# **Alterations and additions to Campbell's Stores**

State Significant  
Development  
Modification Assessment  
(SSD 7056 MOD 2)

September 2018

**Figure 4** | The approved (above) and proposed (below) powder-coated louvre wall in the loading dock  
(Source: JPW Architects).

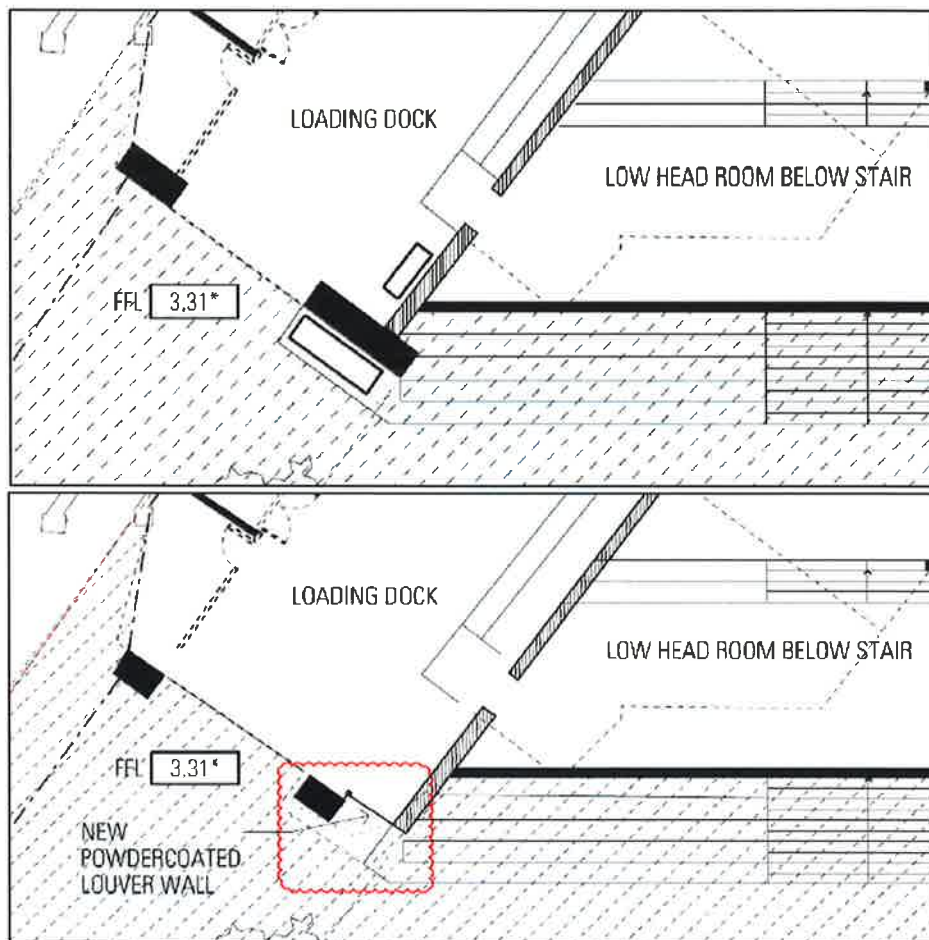
### **Louvre wall in the loading dock and two new air vents in Bay 6**

The new powder-coated louvre wall in the loading dock has been included to improve the natural ventilation through the building. Similarly, the proposed air vents located under the eaves of Bay 6 are included to prevent the build-up of hot air beneath the Bay 6 skylight.

The Applicant proposes to install a louvre wall and two new air vents (**Figure 13**) to improve the natural ventilation through the building. The Department considers these amendments to be suitable as the Bay 6 air vents are concealed behind the bargeboard and are therefore not visible from the public domain and the louvre wall would improve ventilation to the loading bay without diminishing the heritage value of the building. Both changes would also not be visible from the Sydney Opera House UNESCO World Heritage site. Due to the minor nature and

concealed locations of the proposed changes, the Department is satisfied they will not result in any adverse visual or heritage impacts.

**Figure 5** | The approved (left) and proposed (right) Bay 11 roof layout (Source: JPW Architects).

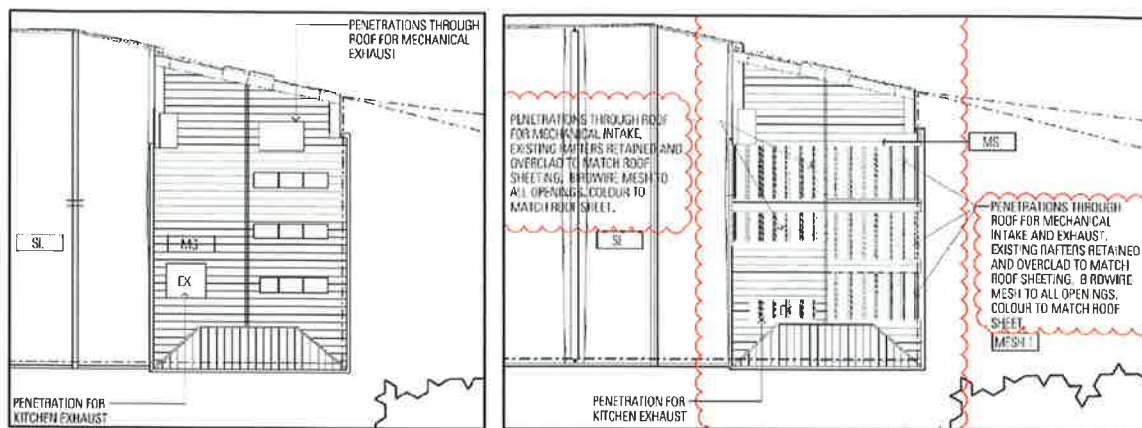
### **Bay 11 plant layout and enlargement of roof penetrations**

The Applicant seeks to modify the plant room layout in the roof space of Bay 11 to reflect design revisions made by the mechanical engineer in response to site constraints. Although SSD 7056 permits the installation of an electric air conditioning system, the lack of electricity available to the site has warranted a new gas-powered system in-lieu of constructing an electrical substation on site. This change relates solely to the air conditioning system and does not seek to change the type or location of the kitchen exhaust system, also located within the Bay 11 plant room.

SSD 7056 approved four penetrations, comprising approximately 17 m<sup>2</sup> of the roof sheeting, to allow for natural ventilation to the Bay 11 plant room. To satisfy the specific open-air requirements of the proposed gas system, the penetrations are required to total 60 m<sup>2</sup> and be covered in a recessive coloured metal mesh.

- the new mechanical exhaust system will result in larger roof openings but this will be mitigated by the installation of the mesh covering
- the changes will have a minor and acceptable visual impact
- the proposed mesh covering results in the roof openings being less visually evident
- the other changes are considered minor and would have negligible heritage impact.

- noise and waste emission impacts arising from the revised exhaust system
- visual impact of the Bay 11 roof openings to residents of Hickson Road
- concerns that the Bay 11 roof openings will catch leaves and rubbish.

Council is supportive of the amended plant and roof design as the mesh coverings will reduce the visibility of the roof penetrations when viewed from 8 Hickson Road. The Heritage Council also consider the proposal would result in a superior visual outcome to what was approved.

The Department considers the proposed mesh covering reduces the visibility of the roof penetrations and that the potential for plant room machinery to be visible through the mesh would be significantly lessened to what is currently approved.

**Figure 6** | The approved (left) and proposed (right) Ground Level, Bay 6 toilet block layout (Source: JPW Architects).

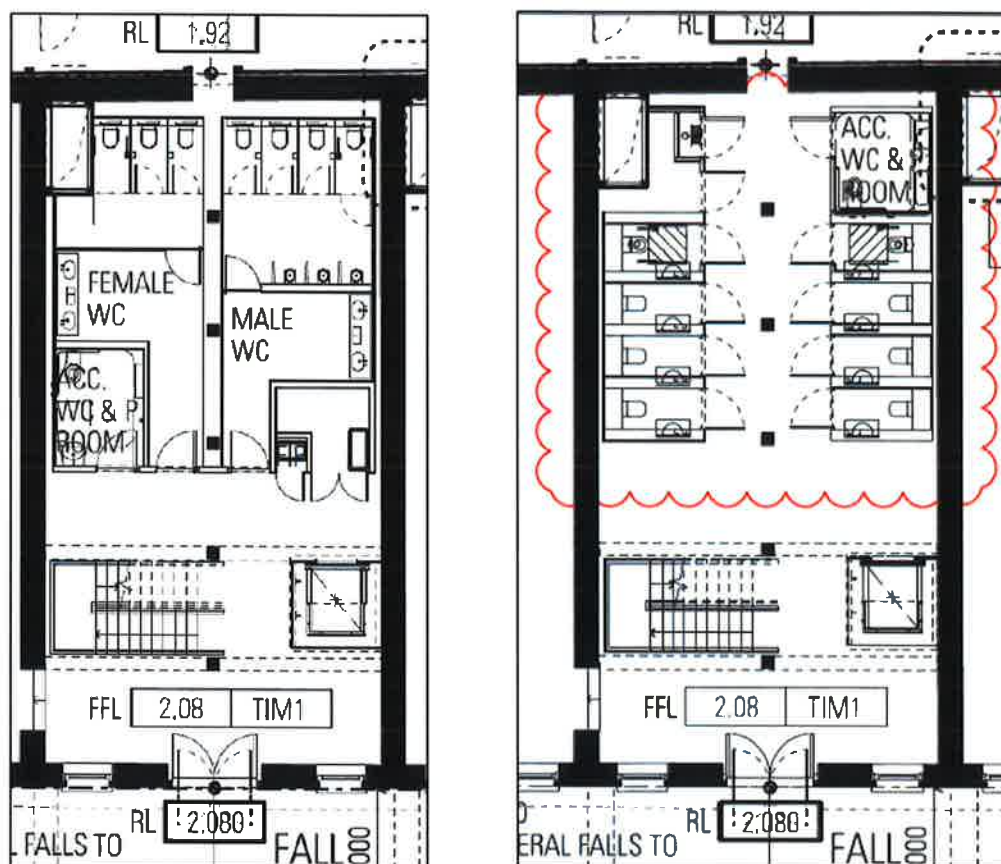
### **Bay 6 toilet layout**

During the design development phase of the project, the male and female toilet layout in Bay 6 has been simplified. The new layout does not demarcate separate male and female bathrooms but maintains the same number of toilets by locating both a toilet and hand-washing sink within individual cubicles. There are no proposed changes to the number of accessible bathrooms.

The proposed modification includes changes to the bathroom layout in Bay 6 (**Figure 6**). None of the Government agency submissions raised concern with the changes.

The Department understands the total number of toilets and accessible toilets is unchanged by this proposal and agrees the change is minor, does not impact upon the heritage value of the building and is unlikely to result in any adverse environmental impacts.

The Department therefore considers the revised toilet layout to be acceptable.
